IMPERIAL ROAD DESIGN MANUAL
REVISIONS July, 2012

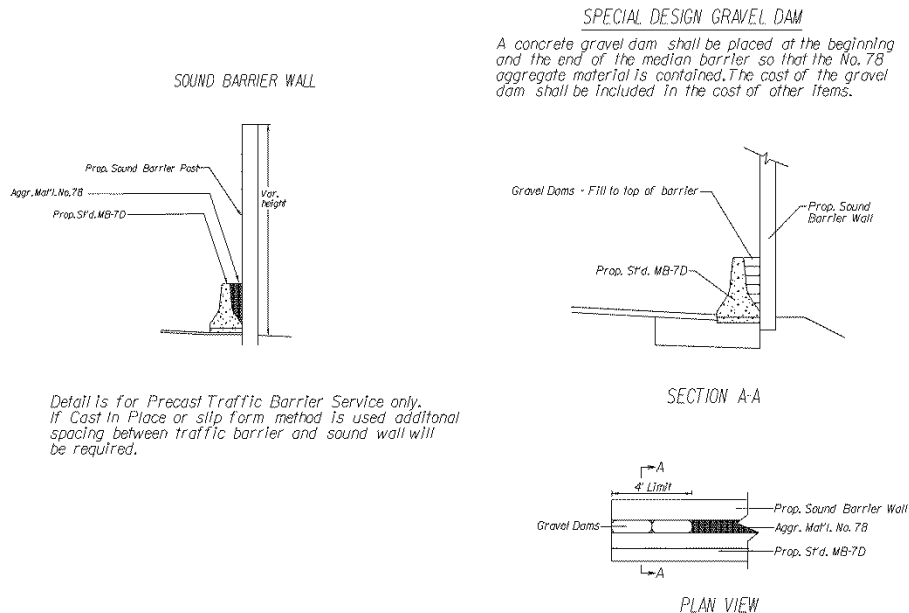
- Page 2E-27 – Added the following language and detail; “*If Sound Wall is adjacent to the roadway shoulder then a Concrete Traffic Barrier Service Standard MB-7D is to be used, see detail below.*”
